ABBREVIATED PLAT AGENDA

**STAFF REVIEW AND RECOMMENDATIONS
PUBLIC HEARING
AUGUST 16, 2023**

ABBREVIATED PLAT: LAURIE MEADOWS RSB BLOCK 1, LOTS 5&6
LEGAL DESCRIPTION: SEC 18, T17N, R01W, SEWARD MERIDIAN AK
PETITIONERS: SUMNER COMPANY
SURVEYOR/ENGINEER: FRONTIER SURVEYS, LLC
ACRES: 2.26 ± **PARCELS:** 2
REVIEWED BY: MATTHEW GODDARD **CASE #:** 2023-087

Plat of:
Lot 5A & Lot 6A
Laurie Meadows RSB

- **LOT 5A & 6A LAURIE MEADOWS RSB Subdivision**

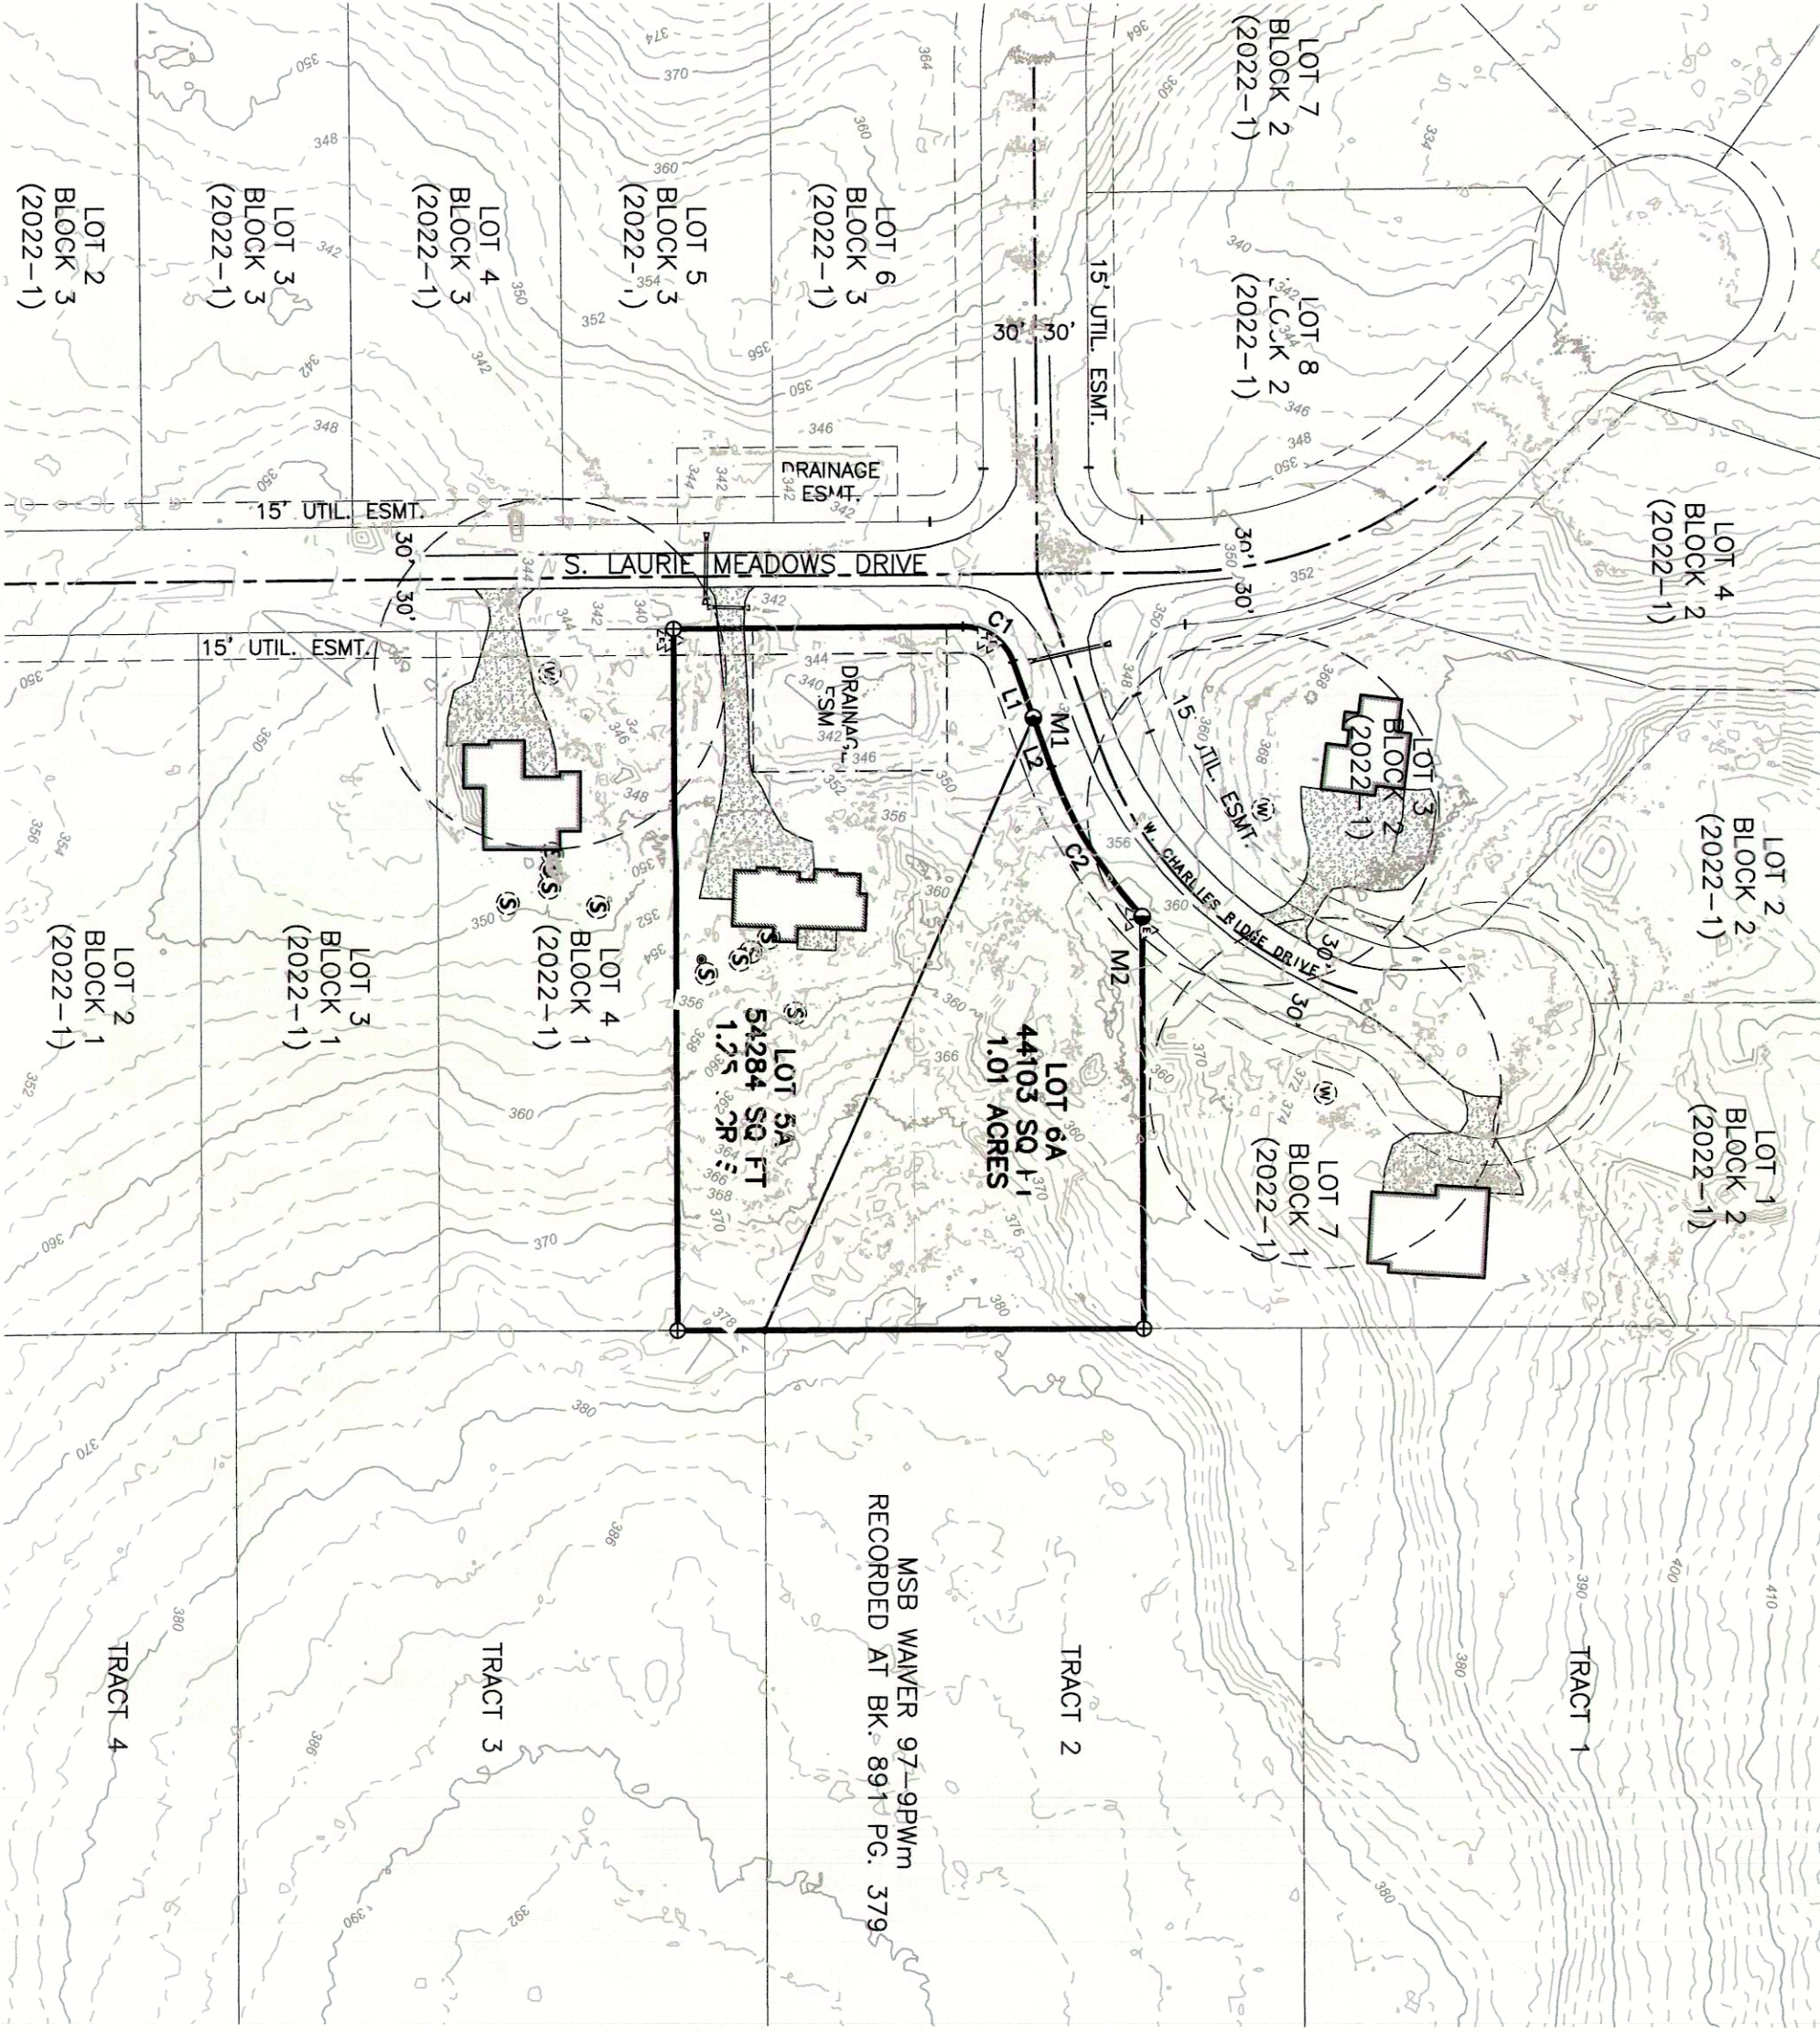
ENSTAR Natural Gas Company has reviewed the following preliminary plat and has no comments or recommendations.
